- Wiltshire councils SFRA which is the online arcgis, live version of the document has flooding maps that show the extent of flooding based on historic floods rather than modelled estimates.

- Despite the EA requiring a main modification in the current core strategy for Warminster that a SFRA 2 for the town be done due to the complex nature of flooding and the unknown interactions of various flood sources and topography, or the capacity and effectiveness of current flood management infrastructure to cope with current demands on it, let alone those increases due to climate change, this has not been done.

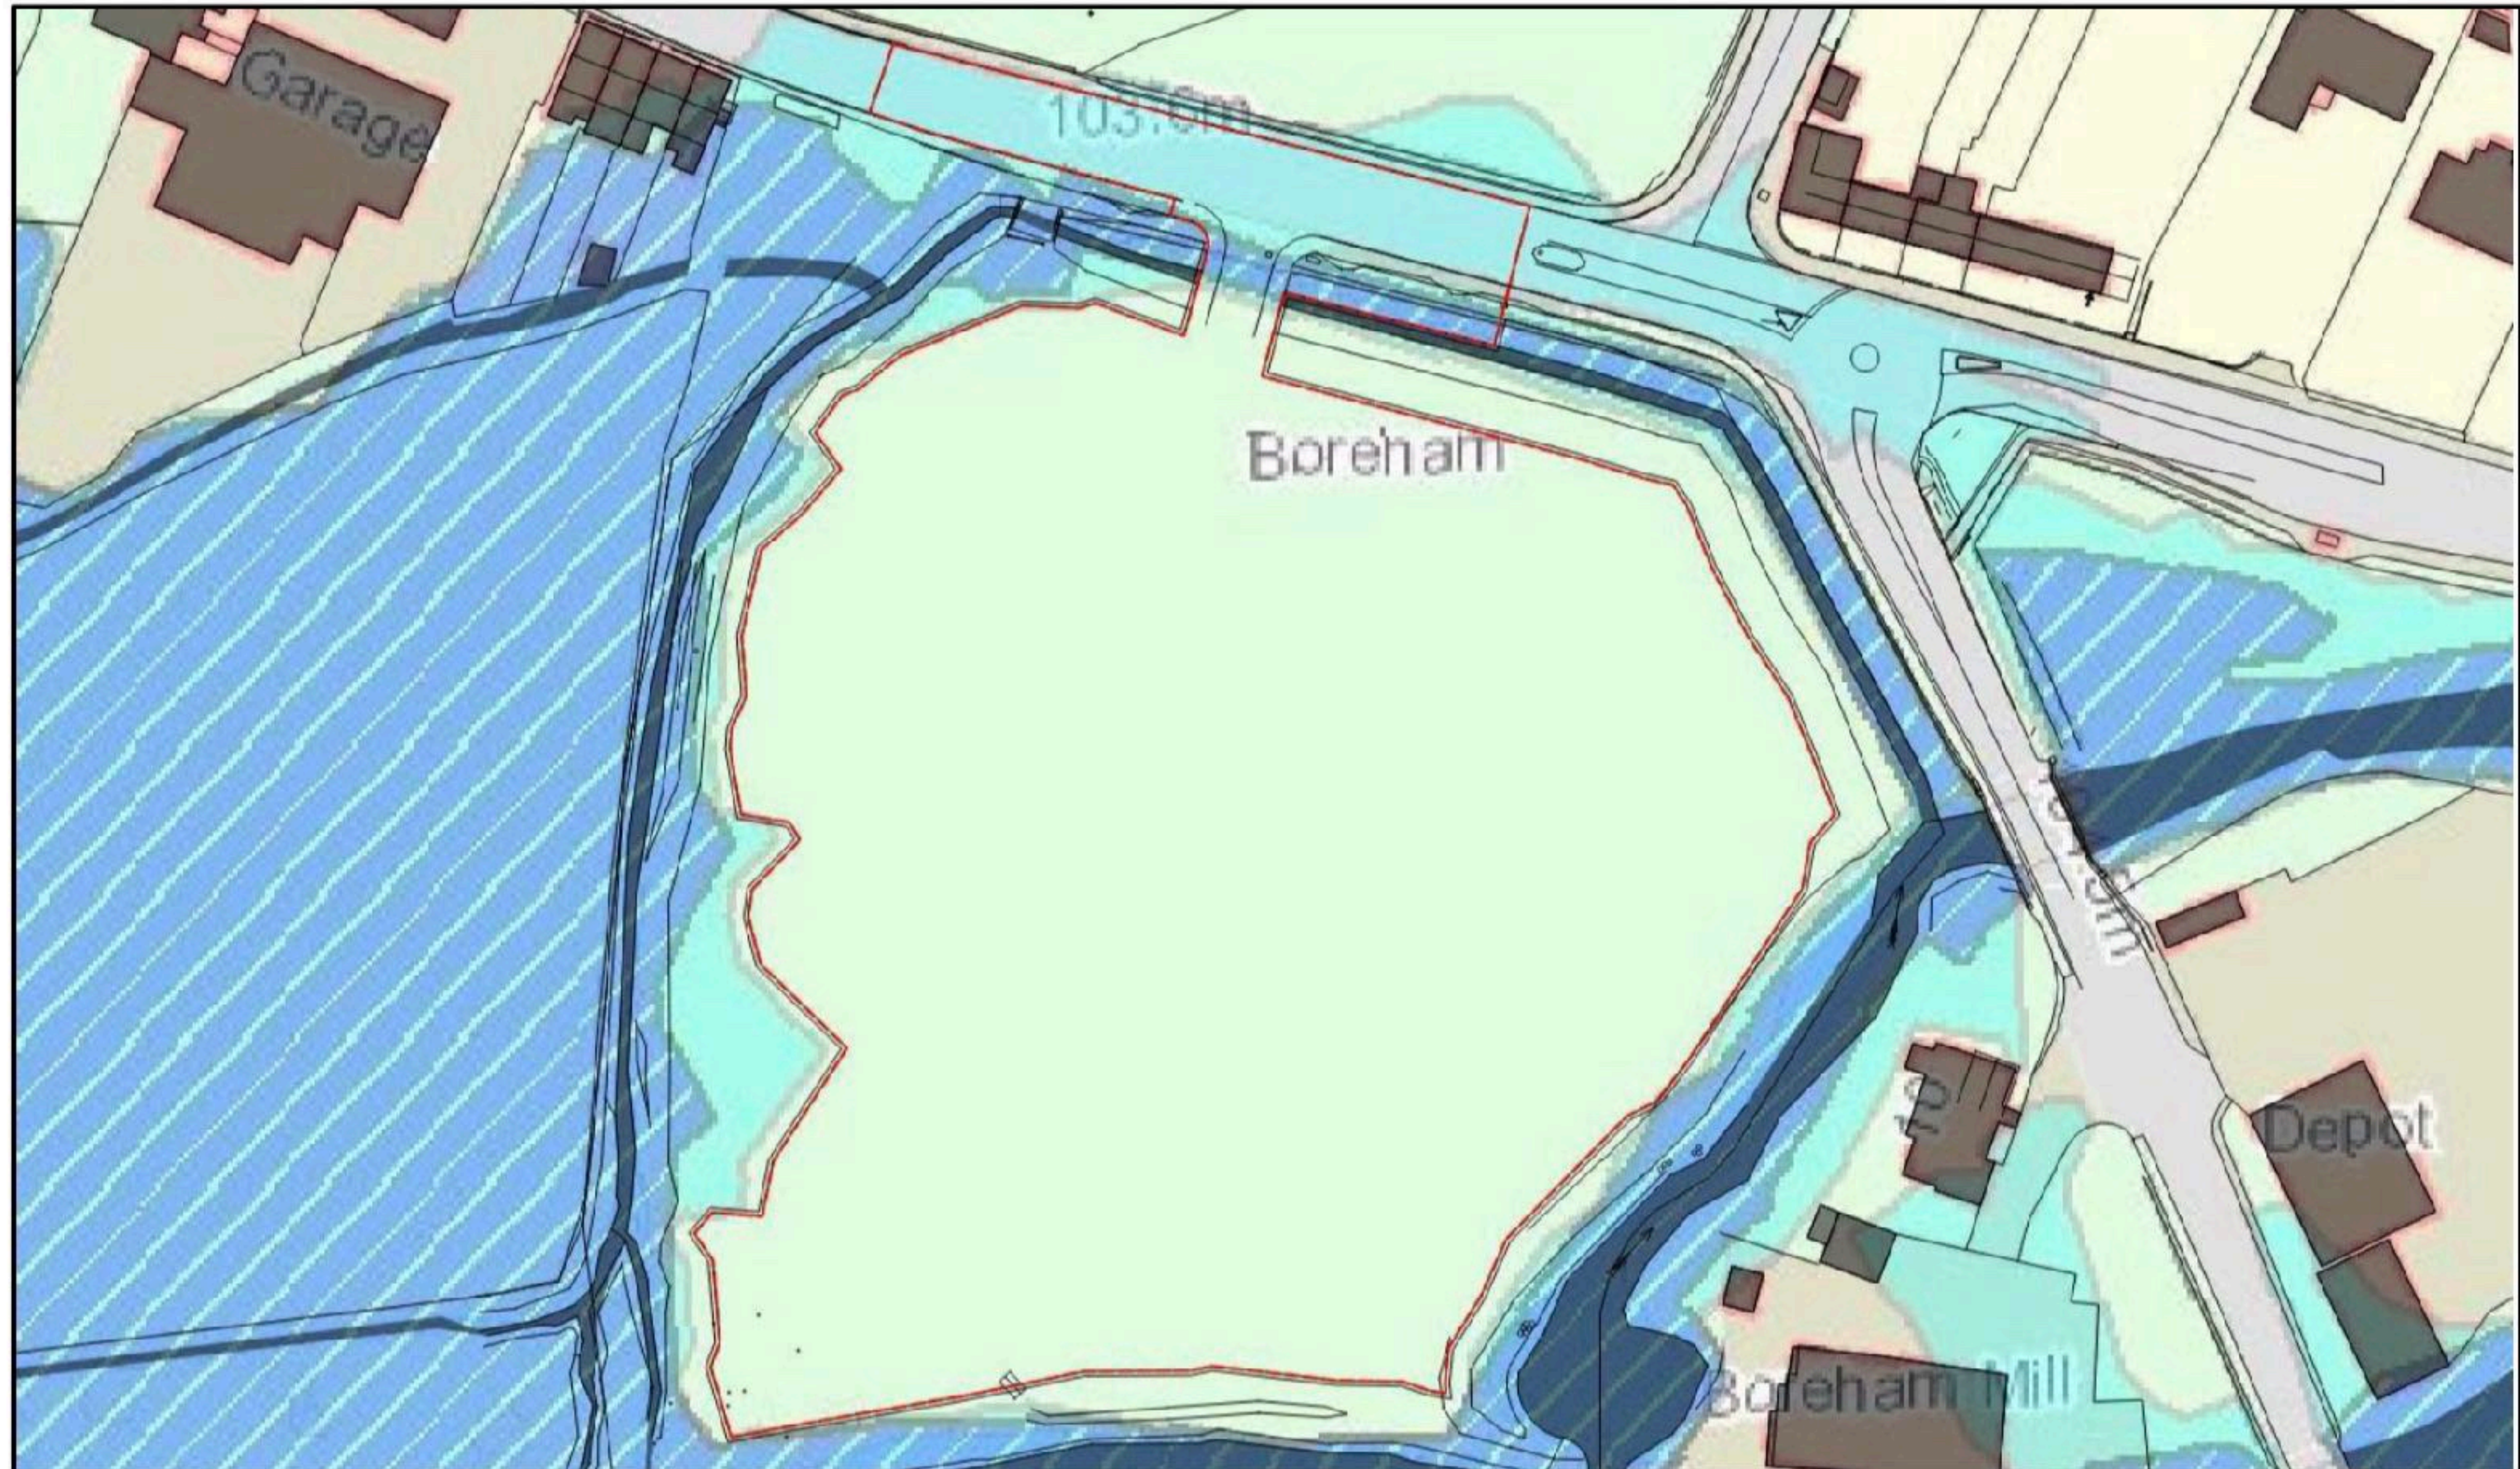
- Above is the final flood extent map agreed by the EA which allowed the development to proceed as no development would be in zones 2-3.
- Despite this so called safe site being all zone 1 the EA and developer agreed to raise the site further to prevent future flooding which should not be necessary on safe sites, and in raising the site further they again failed to provide any additional flood storage as required in the nppf.
- English law states that you cannot adjust your land in such a way as to redirect flood water onto another's unnaturally. This action is classed as a nuisance and is the core legal principal behind the nppf policy that development cannot increase flood risk to others. So the site was raised, twice, pushing water round it onto the road and into park cottages, creating a nuisance and liability for the developer and new owners.

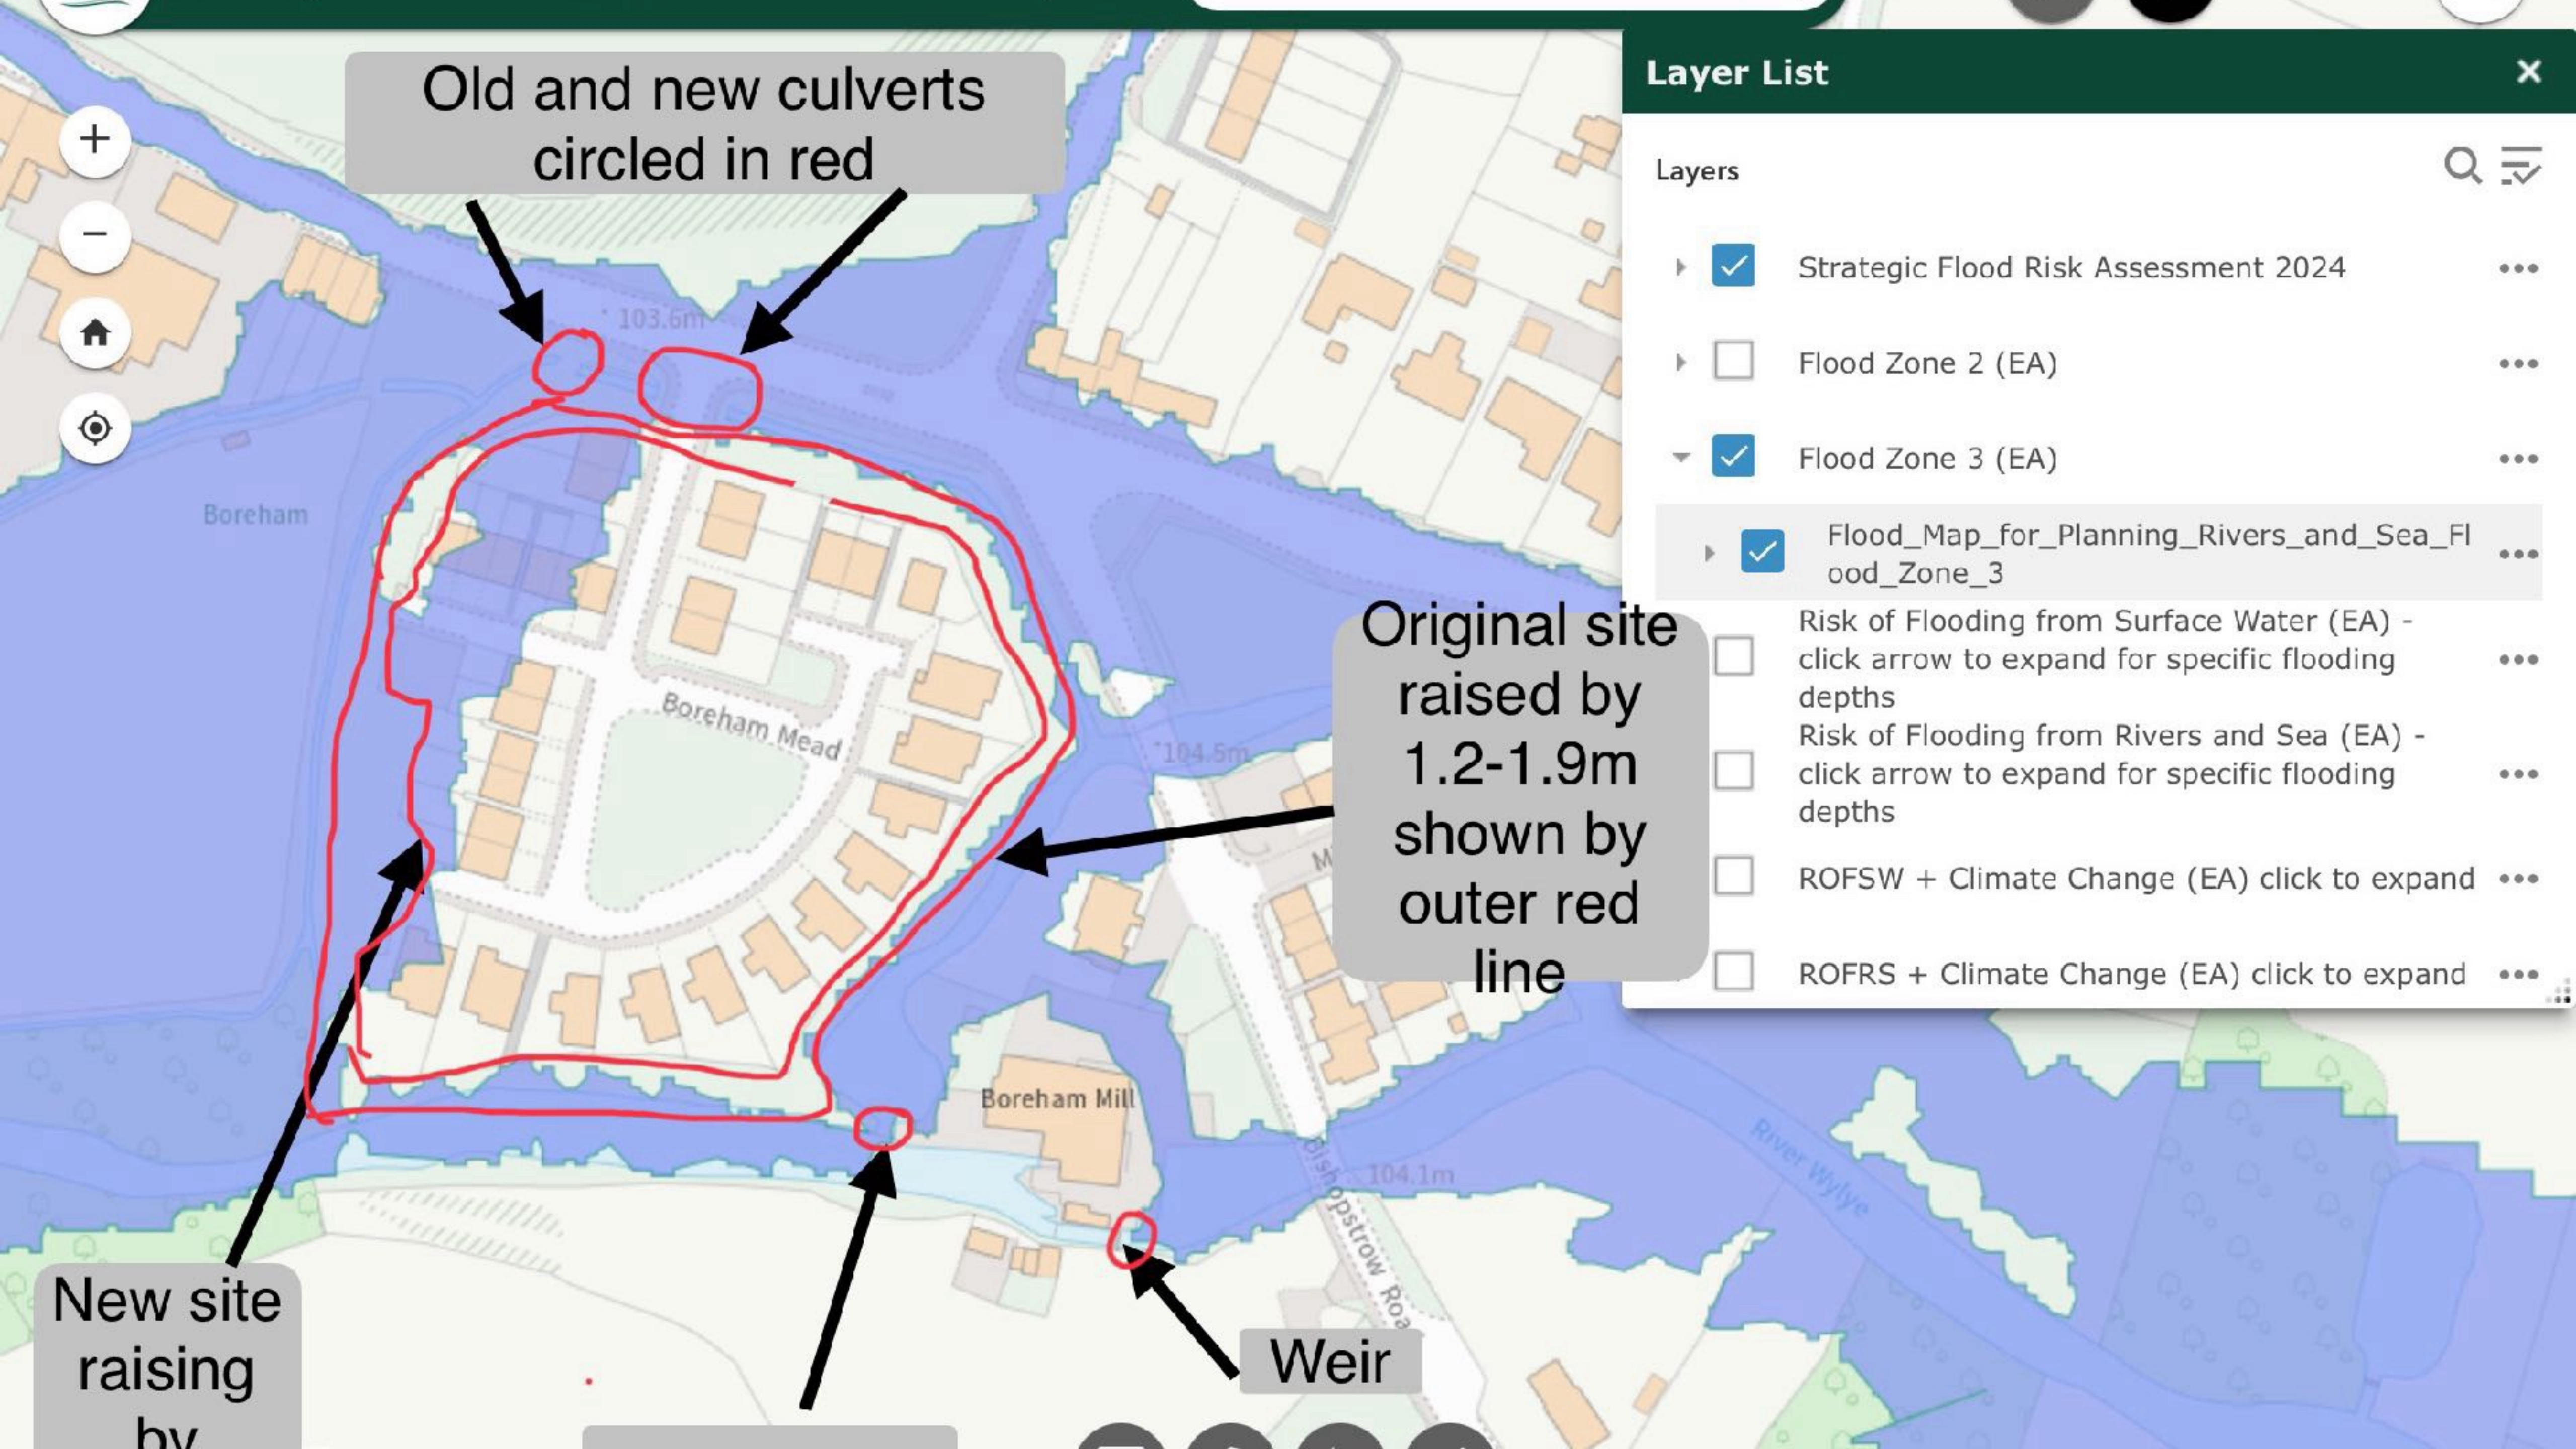
- In 2019/20 the EA and council undertook a hydrological assessment of the town and the results changed the flood extent across the town increasing it significantly in many places, one of which was Boreham mead, which now shows half the site under water, which would have prevented this site from being built, if the assessment had been done prior to the planning approval as agreed in the main modification.
- This now leaves a known increase in flood risk to surrounding properties unmanaged, as despite the change to the map neither the EA or council required a reassessment of any effected area, or a recalculation of the risk now posed by flooding and if the agreed mitigation measures were fit for purpose.
- This lack of action allowed the site to be built out and then caused the significant floods of 2034&24 where houses were flooded and cars damaged in flood waters.
